R44 SERVICE BULLETIN SB-112B
(supersedes R44 Service Bulletin SB-112A)

SUBJECT: Tail Rotor Blade Inspection and Replacement

EFFECTIVITY: P/N C029-3 tail rotor blade S/Ns 14329 and prior (C029-3 REV Q and prior). Affected blades were factory-installed on the following aircraft:

SPECIAL TAIL ROTOR TIP PREFLIGHT INSPECTION

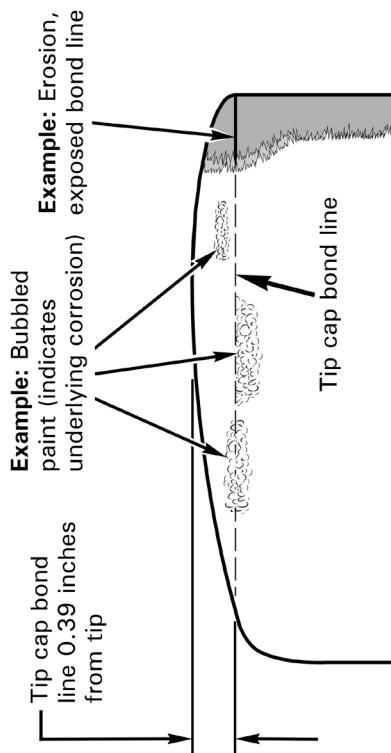
To be performed before the first flight of each day. May be performed by pilot or mechanic. Conduct visual inspection of tail rotor tip area. If bubbled paint or other evidence of corrosion is observed at or adjacent to tip cap bond line or if any portion of tip cap bond line is exposed, do not fly helicopter. Comply with latest revision of R44 SL-82 prior to further flight.
